Your ref: 68530
Maze ref: 346.03

12 October 2022

Planning application reference 68530
Proposed commercial buildings, sports pitch, and highways
JD Campus, Hollins Brook Way, Pilsworth, Bury, BL9 8RR

Figure 1 – Extract from Proposed Site Plan 11302-AEW-XX-SI-DR-A-0504 P06

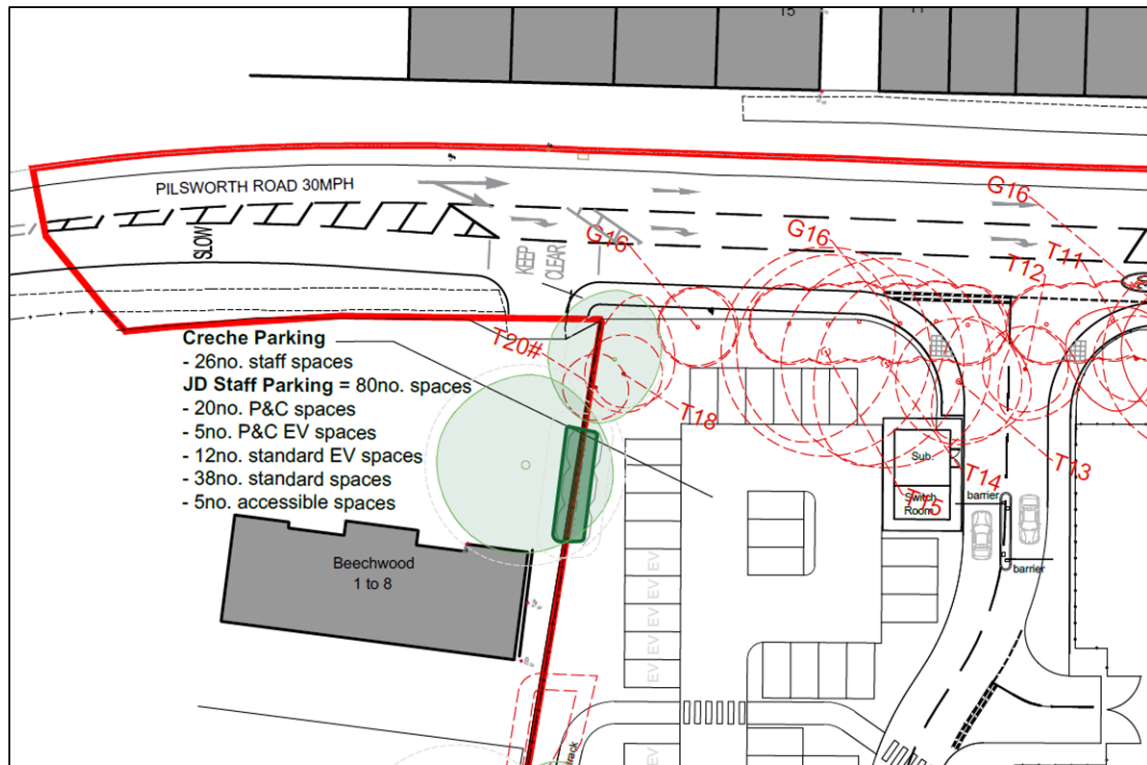
- **Beechwood Apartments junction** – the proposed highway works to be undertaken by JD if planning permission is granted have been amended to include provision for a right turn ghost lane in the centre of Pilsworth Road. The lane provides space for residents turning right into Beechwood, out of the flow of main traffic, and creates a protected ‘pocket’ that will aid the right-turn-out manoeuvre when exiting Beechwood. When combined with ‘Keep Clear’ carriageway markings, this proposed arrangement should improve the way the junction functions for the residents.

Figure 2 – Extract from Creche North East Elevation 11302-AEW-02-XX-DR-A-0531

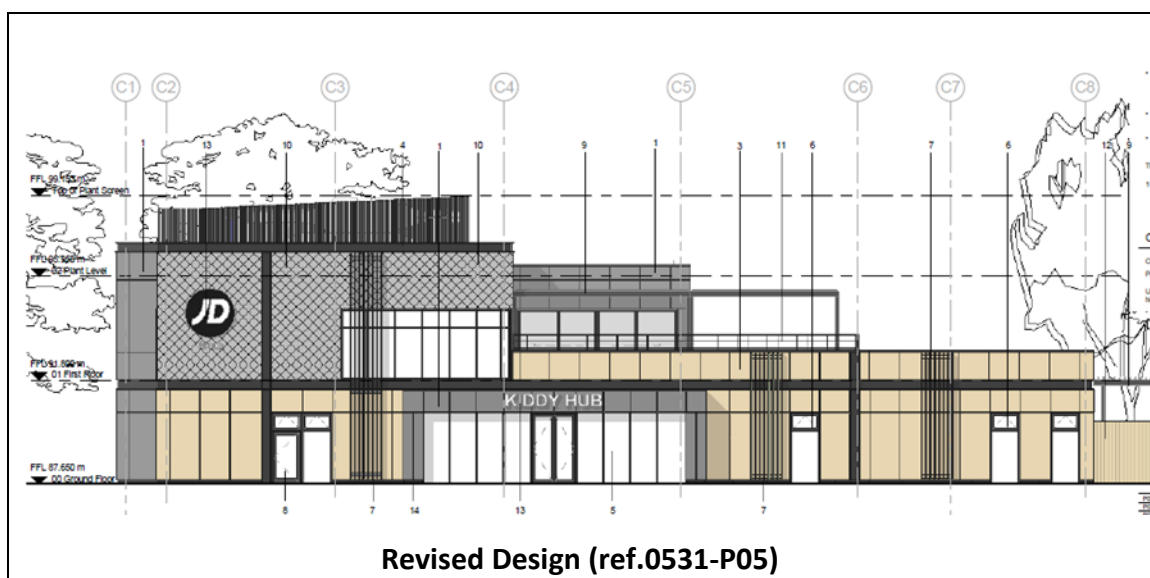
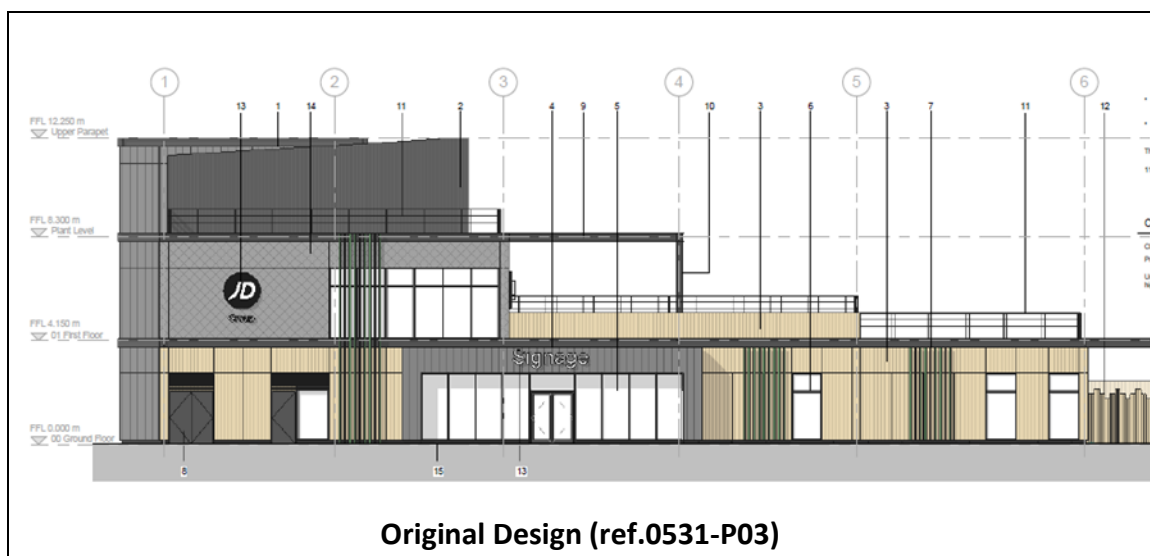
- Creche Building Height** - the height of the creche building has been significantly reduced. Some neighbours commented that it had potential to appear large and potentially overbearing on the boundary because of the level difference between the development site and its neighbours. The building design has been adjusted by JD's design team to remove the plant room level, which reduces the building parapet height by 2.6m metres [from 12.25m to 9.65m above ground level]. Equipment that would have been contained in the plant room has been relocated to an internal plant room at first floor level, leaving only essential external equipment like air handling units mounted on the roof, set behind a low screen which has also been reduced in height as part of this design review.

Figure 3 – Revised Landscape Planting Proposals

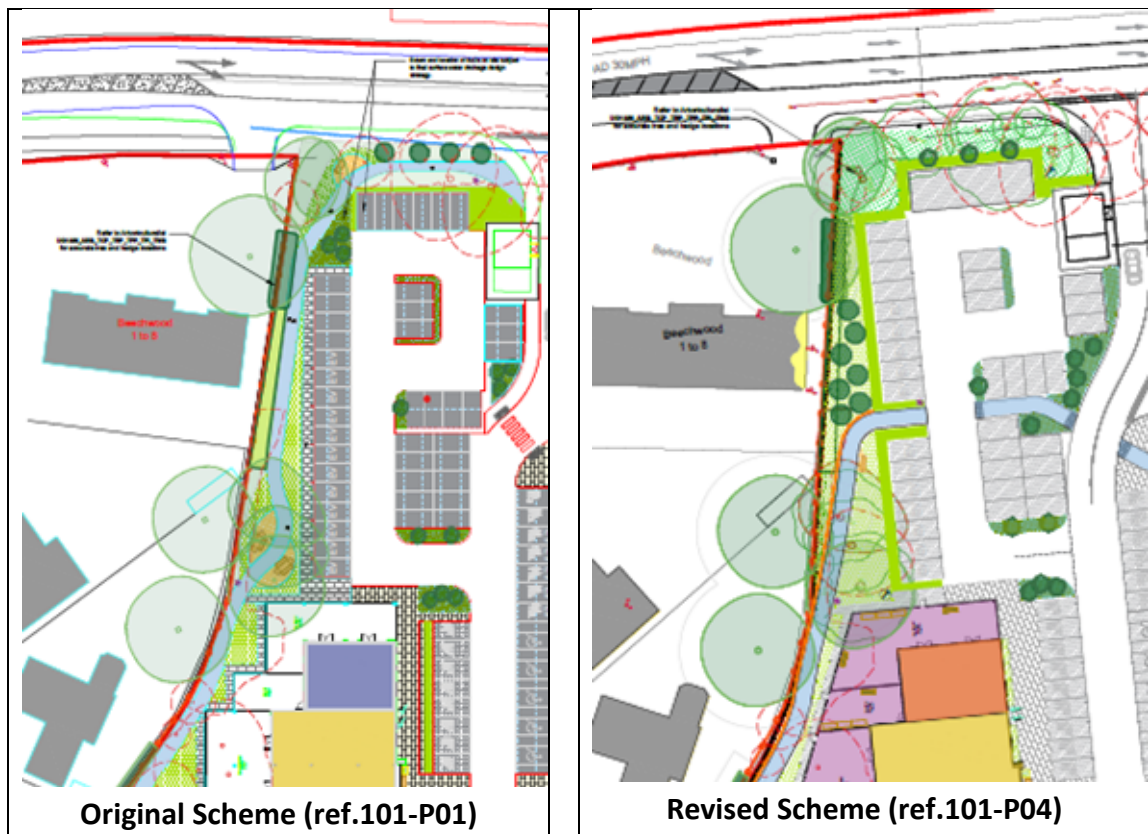
- **Boundary Landscaping** – residents were concerned to ensure good quality landscape treatment of the common site boundary. Beechwood residents noted that existing trees (leylandii and others) had provided a screen to the previous industrial use and the now vacant development site. JD’s landscape adviser has revised the landscape plans to bolster the proposed planting adjacent to Beechwood Apartments and provided assurances to residents that stout, good quality trees will be used to ensure an immediate positive impact. Residents were reassured that the proposed phasing of development would see the creche constructed first, together with landscape planting of the common boundary.
